December 16, 2015

Mr. Kenneth Harris Division of Oil, Gas & Geothermal Resources Department of Conservation 801 K Street, MS 24-02 Sacramento, CA 95814

ATTN: Aquifer Exemption

On behalf of the Natural Resources Defense Council ("NRDC"), which has 2.4 million members and activists, more than 380,000 of whom are Californians, and Clean Water Action ("CWA"), which has 1 million members nationwide, 50,000 of whom are Californians, we write to submit our comments on the supplemental information for the proposal to expand the current aquifer exemption designation for the Dollie Sands of the Pismo Formation in the Arroyo Grande Oil Field located in unincorporated San Luis Obispo County, near the intersection of Ormonde Road and Price Canyon Road.

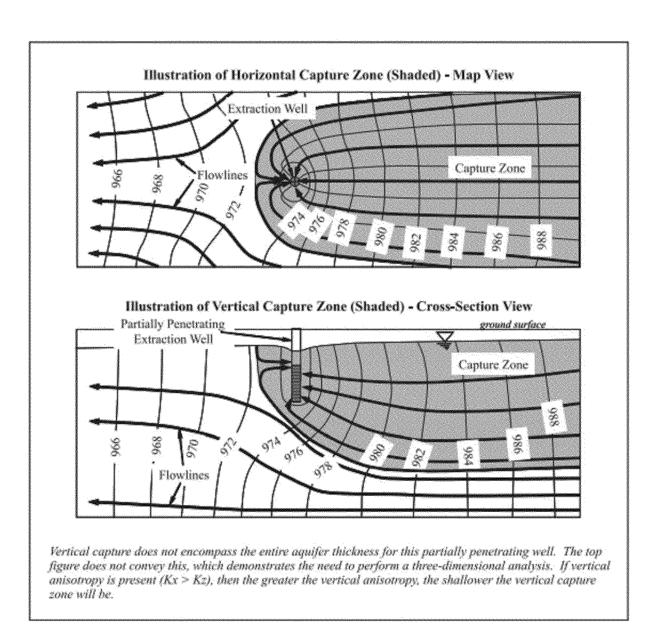
It appears that the proposed aquifer exemption boundary was drawn in an effort to avoid current water wells rather than actually performing the analysis necessary to determine whether the proposed injection activities could impact those wells. EPA recommends performance of a capture zone analysis ("CZA") to demonstrate criteria 146.4(a); however, the applicant did not perform such an analysis and the concept is not even discussed in the proposed exemption application. The CZA is a scientific characterization of radius of influence around a given pumping well, which largely depends on the pumping rate and intrinsic structural aquifer characteristics (See figure 1). In other words, groundwater located substantial distances laterally and vertically could be 'currently' used by a private well owner, because the radius of influence is drawing water. As EPA states, "a drinking water well's current source of water is the volume (or portion) of an aquifer which contains water that will be produced by a well in its <u>lifetime</u>." NRDC raised these issues in our previous written comments and this was not addressed or acknowledged.

In other words, arbitrary land boundaries have absolutely no impact on subsurface flow and groundwater contaminant transport. While the water wells near the proposed aquifer exemption are not *physically* located within the aquifer exemption boundary, the groundwater which those wells withdraw may reside within the aquifer exemption boundary. That would be clarified with CZA analysis; however, a CZA has not been demonstrated and the data required to perform this analysis have not been provided either by the applicant or by the Division of Oil, Gas, and Geothermal Resources ("DOGGR") or the State Water Resources Control Board ("SWRCB").

Clearly, this is an important analysis for demonstrating criteria 146.4(a). As we stated in our initial comments, from a recent aquifer exemption in Texas, EPA denied a portion of a proposed aquifer exemption boundary due to "...significant lack of ground water elevation data for this area." Furthermore, EPA stated "EPA cannot accurately determine whether the area would currently act as a source of drinking water because of the lack of data needed to determine the ground water flow direction north of the Northwest Fault." Therefore, EPA rescinded a portion of the aquifer exemption that did not have sufficient ground water information to show that the aquifer was not currently being used.
